Access Compliance Report

Public Rights-of-Way

(Curb Ramps)

Intersection ID: 14195	Main Street: CLEVELAND_AV	Cross Street: EAST_BV	Location: NE
ADA ID: 79E1A57D6957	Ramp Type: Perp	Initial Pass/Fail: Fail	Overall Compliance: No
Severity Score: 1.25			
Codes/Mitigation Info/Possible Solution		Field Measurements/Component Compliance

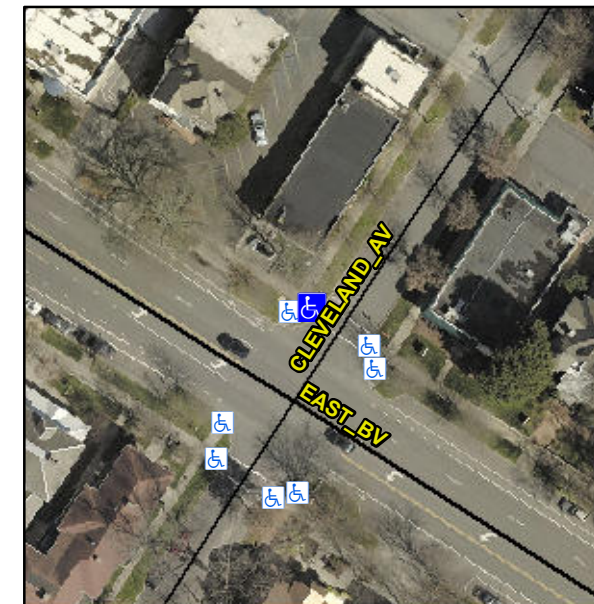
Not Found, R304.5.3

Compliance	Description	Data	Compliance	Description	Data
N/A	Ramp Length (in)	71.0	Yes	Ramp Slope (%)	5.9
Yes	Ramp Width (in)	71.0	No	Ramp XSlope (%)	2.6
N/A	Flare Type LT	N/A	N/A	Flare Type RT	N/A
N/A	Flare Slope LT (%)	N/A	N/A	Flare Slope RT (%)	N/A
N/A	Flare Traversable LT?	N/A	N/A	Flare Traversable RT?	N/A
N/A	Landing Length (in)	N/A	N/A	DWS Provided?	N/A
N/A	Landing Width (in)	N/A	N/A	DWS Contrast?	N/A
N/A	Landing Slope (%)	N/A	N/A	DWS Length (in)	N/A
N/A	Landing X Slope (%)	N/A	N/A	DWS Full Width?	N/A
N/A	Landing Curb? (Y/N)	N/A	N/A	DWS Offset (in)	N/A
N/A	Shared Landing?	N/A			
N/A	Gutter Ponding?	N/A	N/A	Gutter Slope (%)	N/A
N/A	Gutter Lip Ht (in)	N/A	N/A	Gutter X Slope (%)	N/A
N/A	Painted X Walk1?	Yes	N/A	Painted X Walk2?	N/A
	X Walk 1 Direction	To SE		X Walk 2 Direction	N/A
N/A	X Walk 1 Width (in)	110.0	N/A	X Walk 2 Width (in)	N/A
	X Walk 1 Slope (%)	3.1		X Walk 2 Slope (%)	N/A
	X Walk 1 X Slope (%)	0.6		X Walk 2 X Slope (%)	N/A

Remove & Replace Entire Ramp.
